Mitigation Plan

Mushroom Meadow Mitigation Site

Caswell County, North Carolina
Roanoke River Basin HUC 03010104
DMS Project ID No. 100192
Full Delivery Contract No. 200204-01
USACE Action ID No. SAW-2021-00348
NCDWR No. 20210400, V1

Subject: Mitigation Plan
Mushroom Meadow Mitigation Project, Caswell County
Roanoke River Basin HUC 03010104
USACE Action ID SAW-2021-00348/NCDWR 20210400, V1

01/11/2023
DATE
39077.34
PROJECT NO.
PSH-02.2.5
SHEET

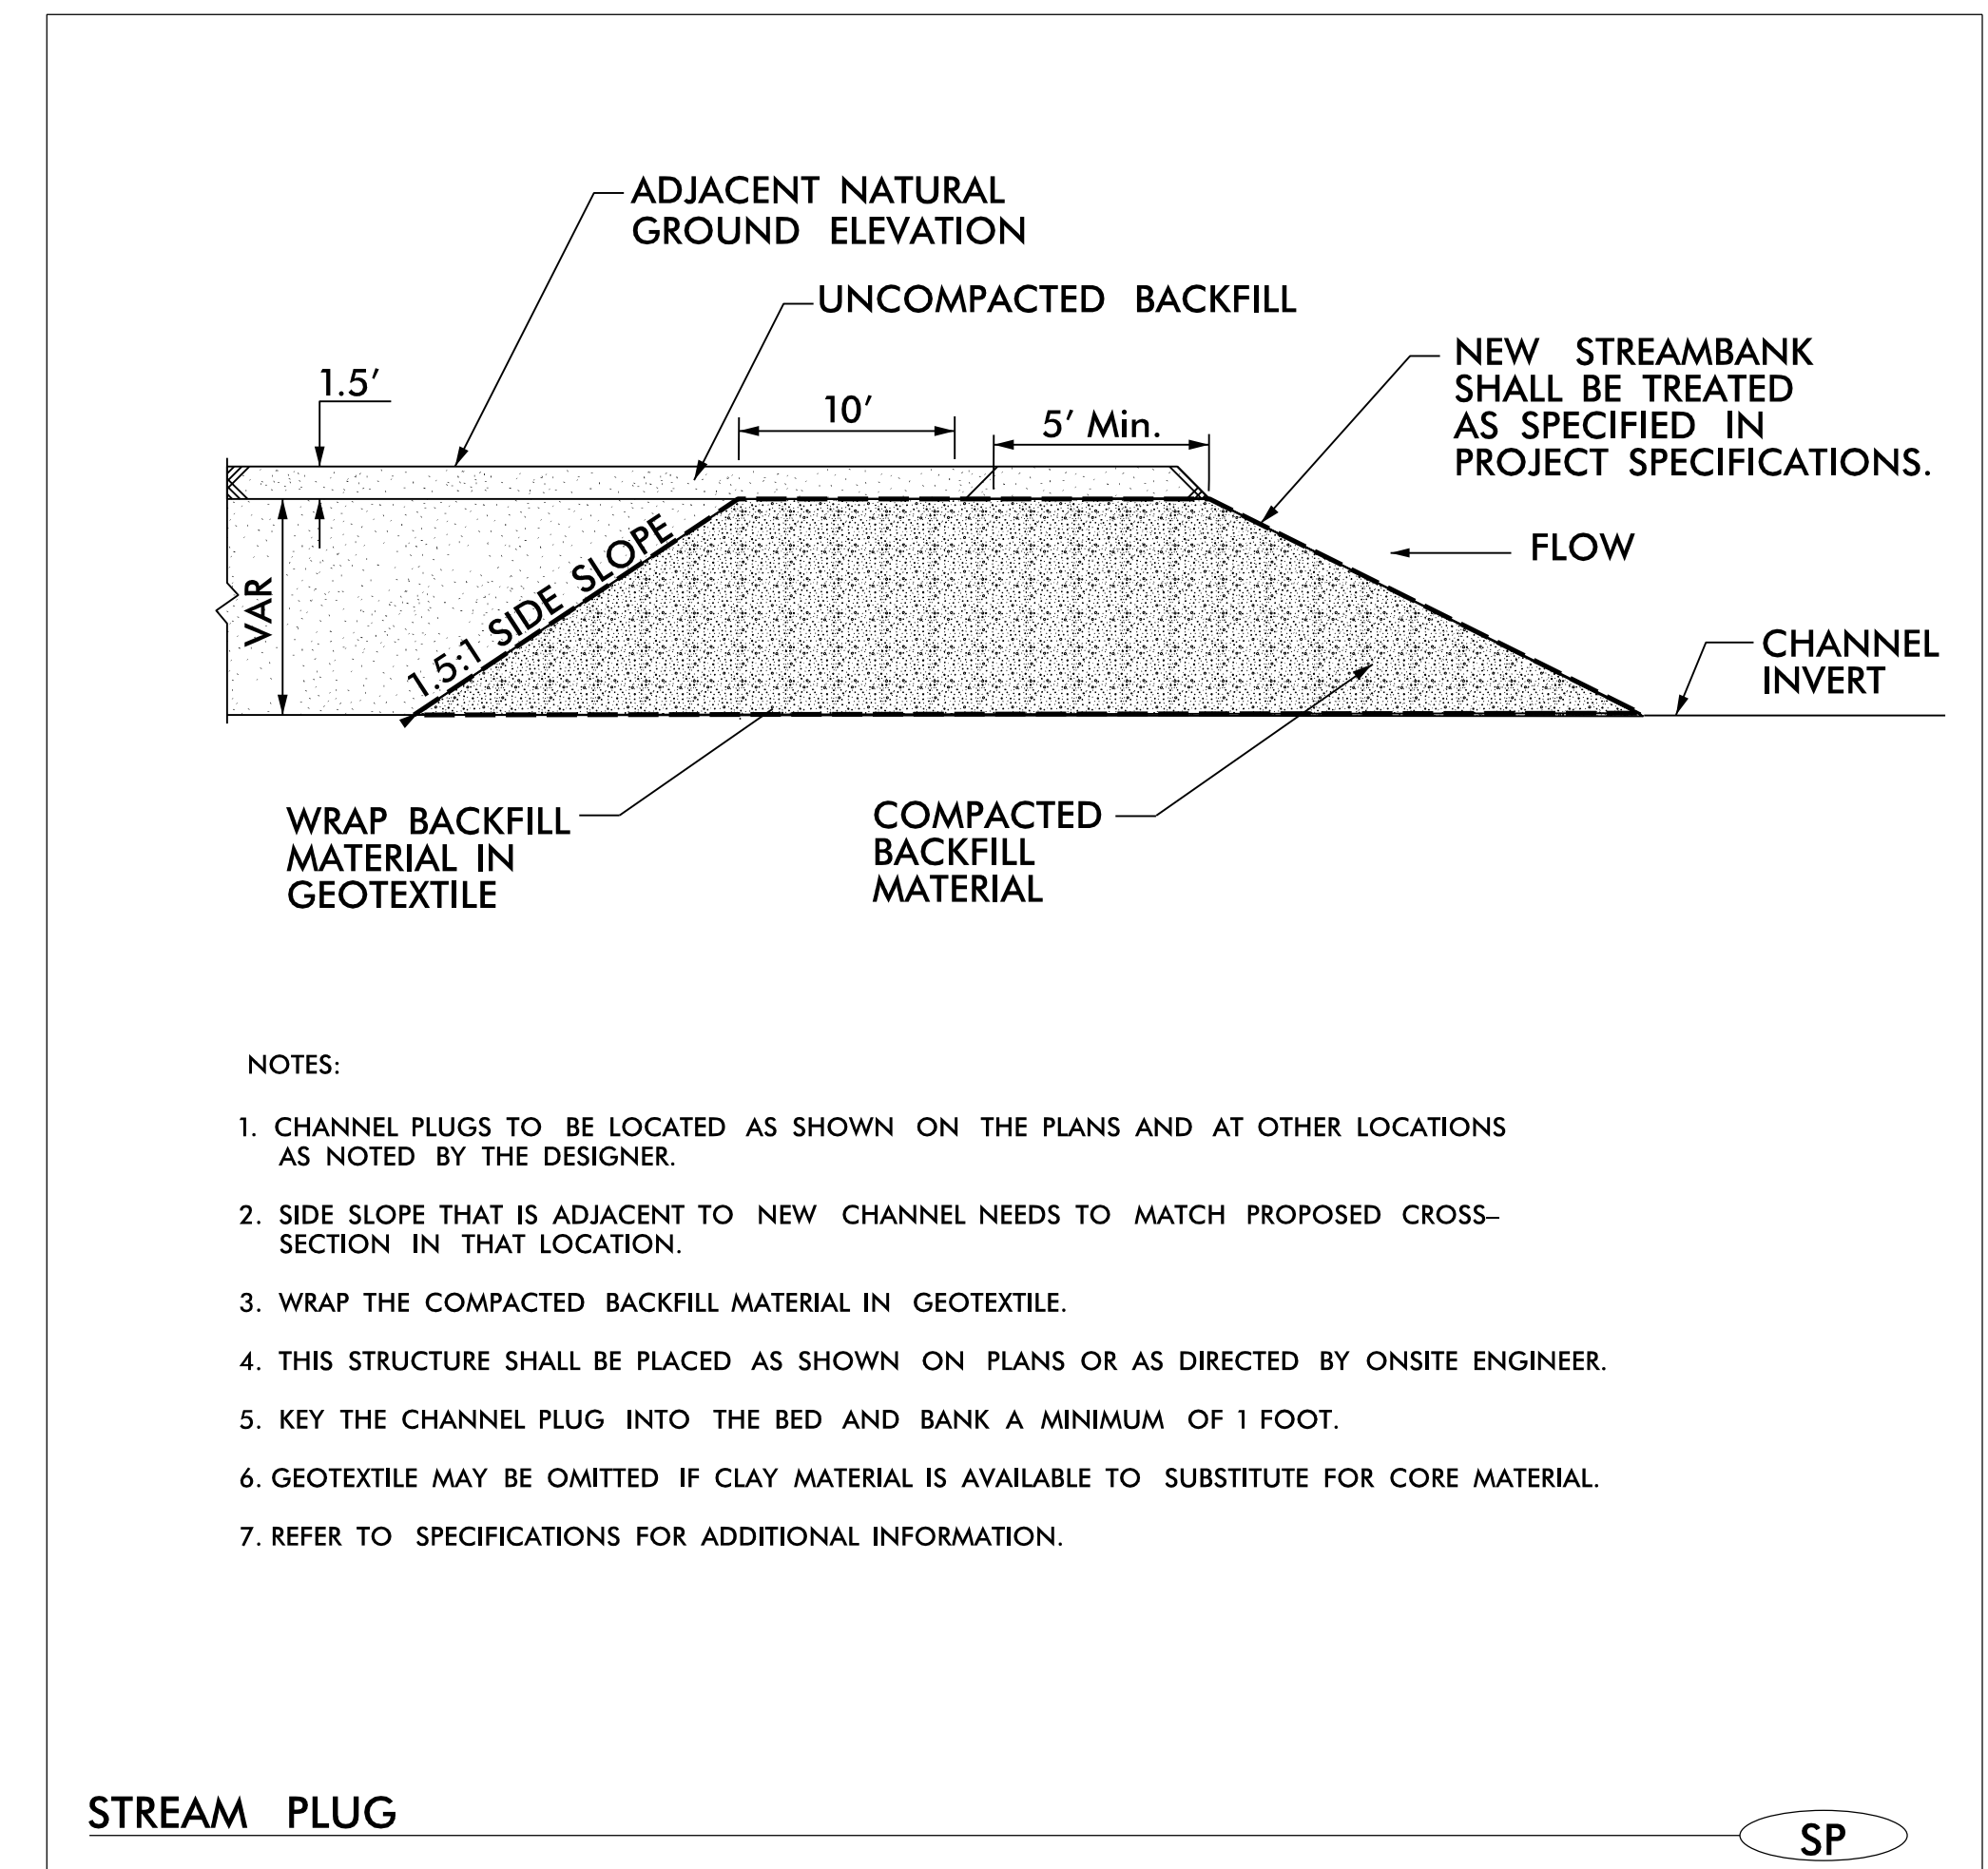
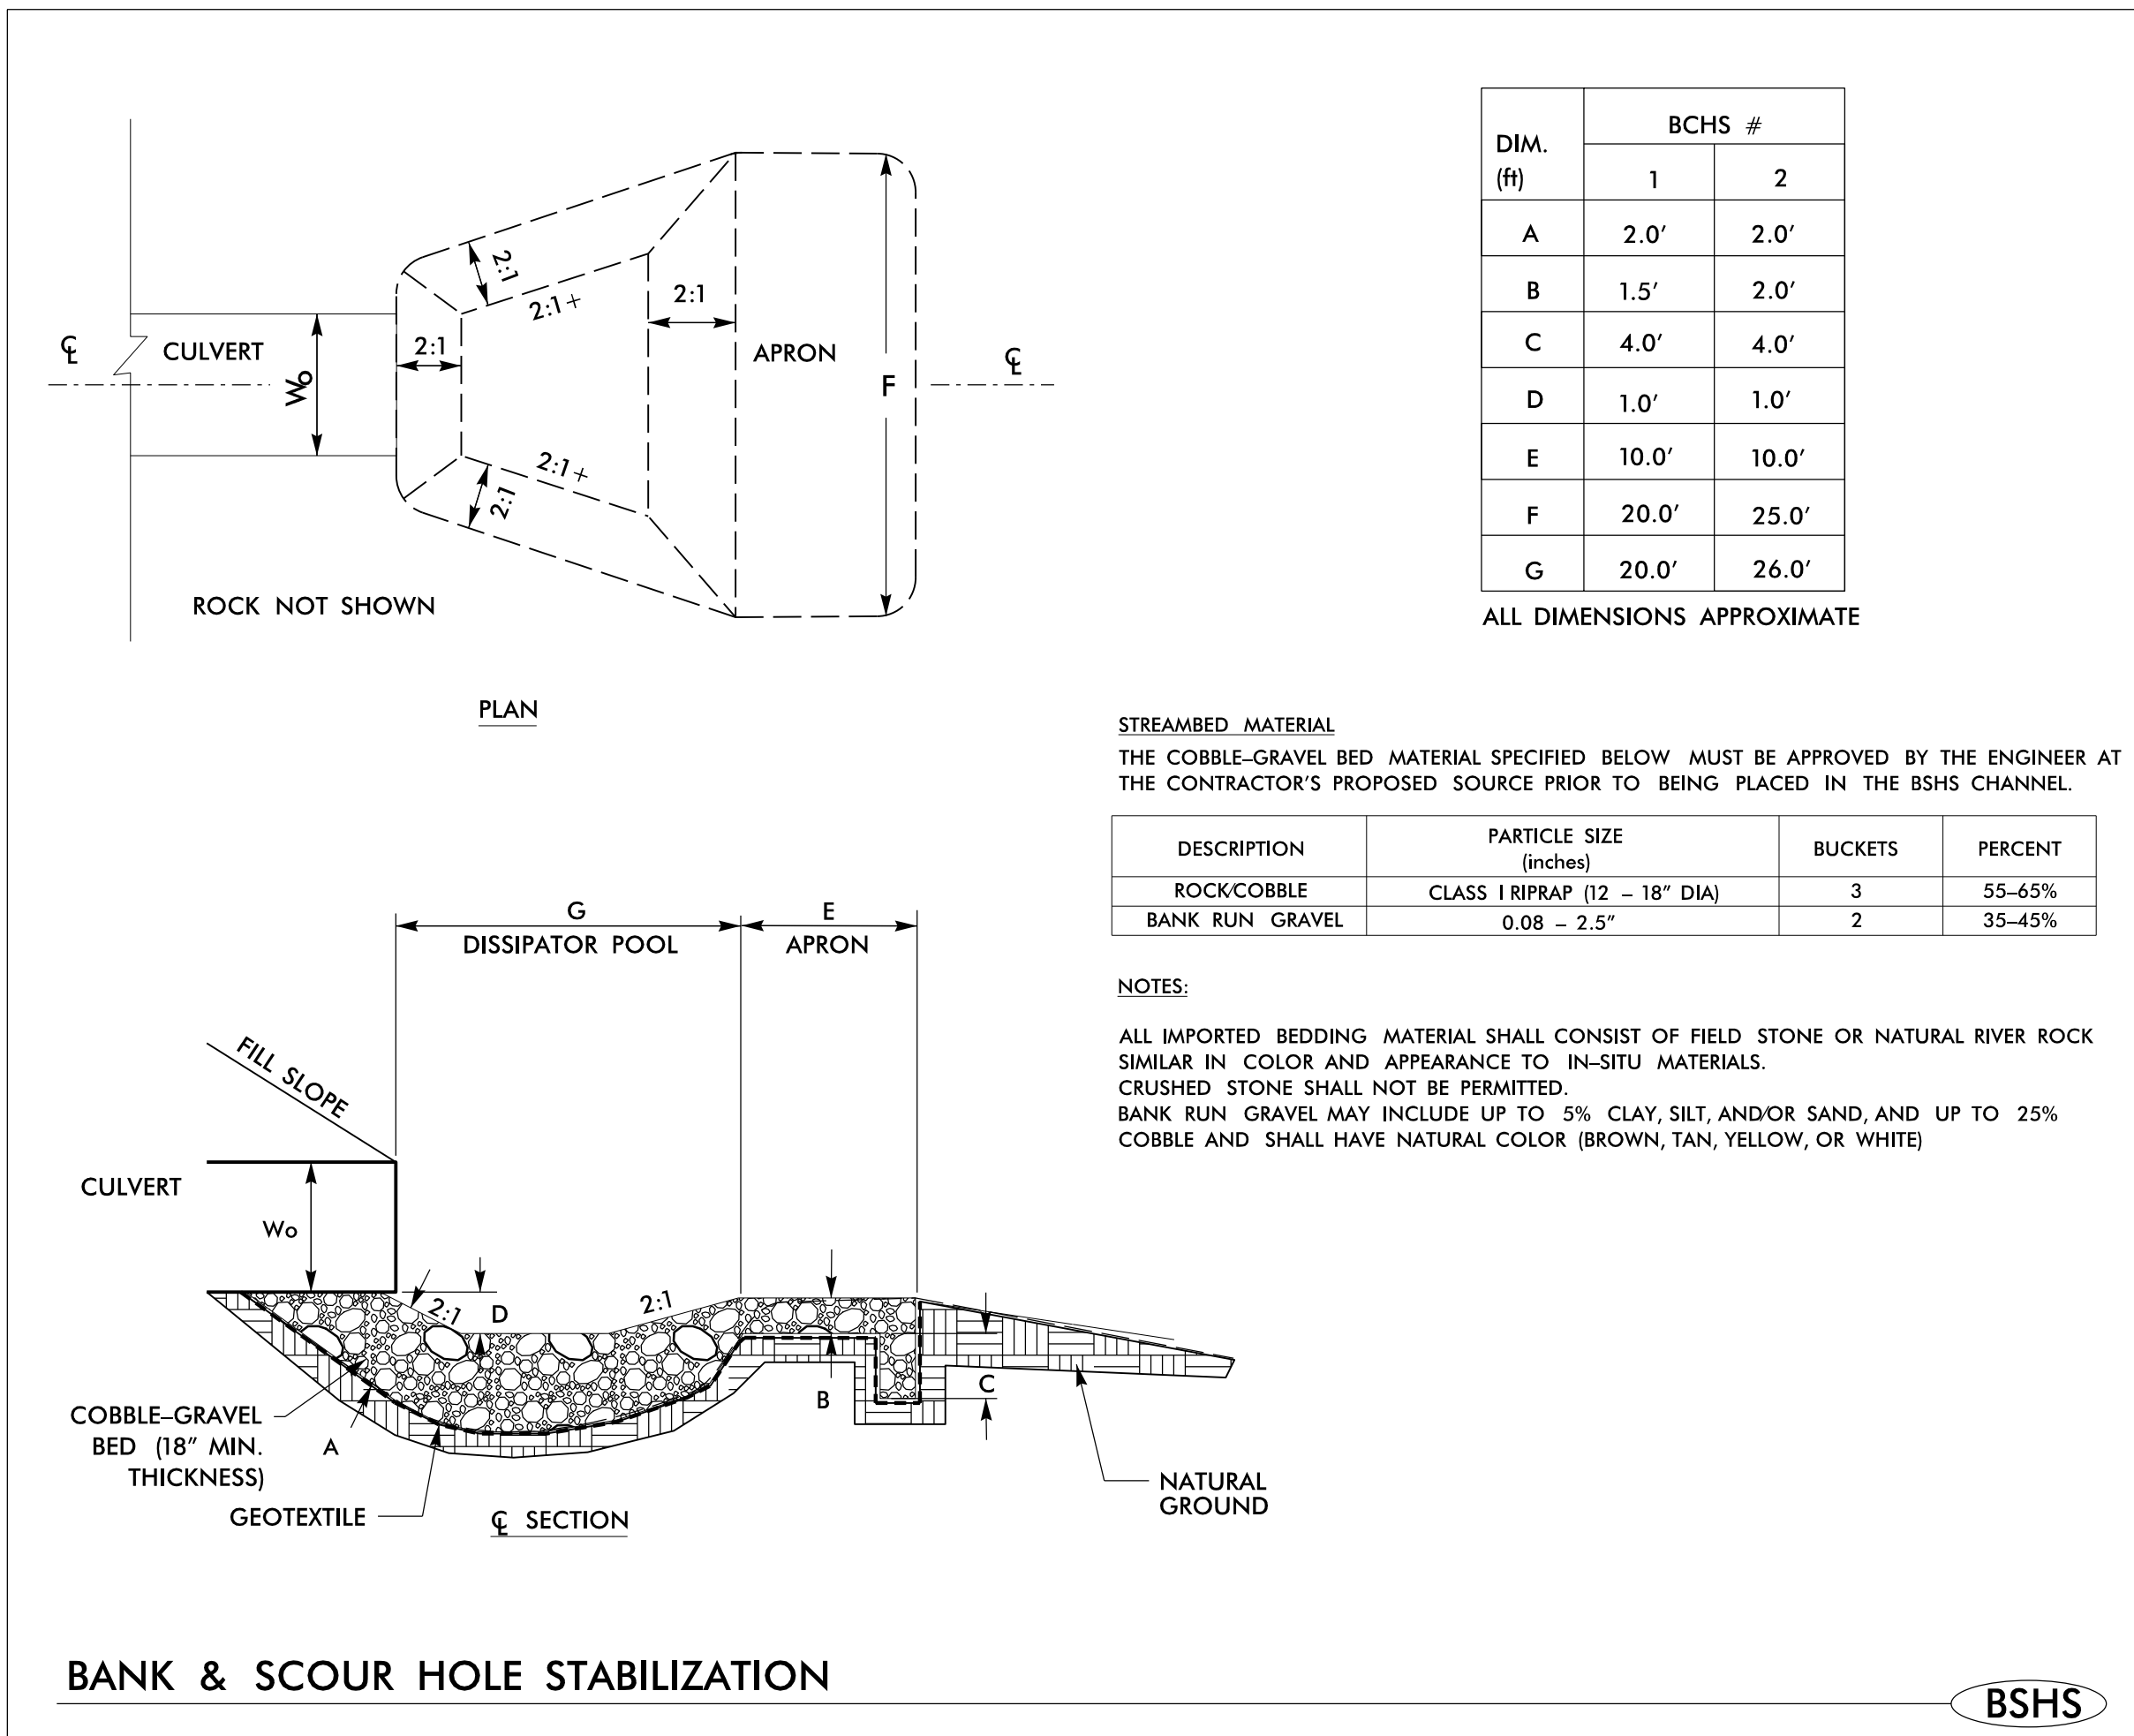
28. Sheet PSH-02.2.5 – Please consider aquatic passage in the max. depth determination and onsite construction of proposed drop structures. **The aquatic passage has been considered in the design of all drop structures. No proposed drop structure that has perennial flow has a greater than 1.0' drop. The max depth is greater at the double drop vane on UT1 since it is intermittent flow, and not applicable in the case of the Embankment Stabilization to the Dan River.**
